Product Change Notification: E-21-002545 PCN Date: 04-MAR-21

DEUTSCH W8S DT 8-Way Plug Wedge Lock Change

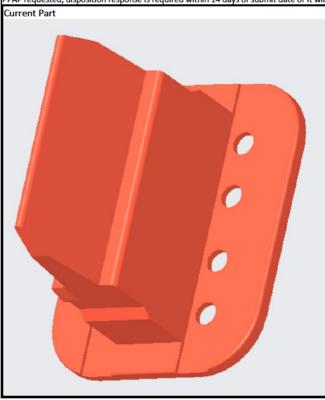
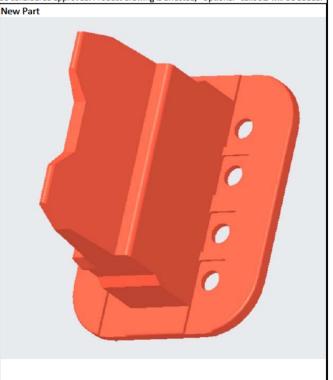
The Industrial and Commercial Transportation business unit of TE Connectivity is making a change to the form of the W8S part number. An optional cutout feature will be added to the wedge lock in the "blade" area and optional ribs will be added in the flange area. This PN is TE proprietary designs, therefore considered catalog/general market product. PPAP and/or sample requests must be submitted within 14 days of PCN submission via ict-ppap-request@te.com or ePPAP system. Submission will not occur without request. If PPAP requested, disposition response is required within 14 days of submit date or it will be considered approved. Product drawing is affected, "Optional" callouts will be added.
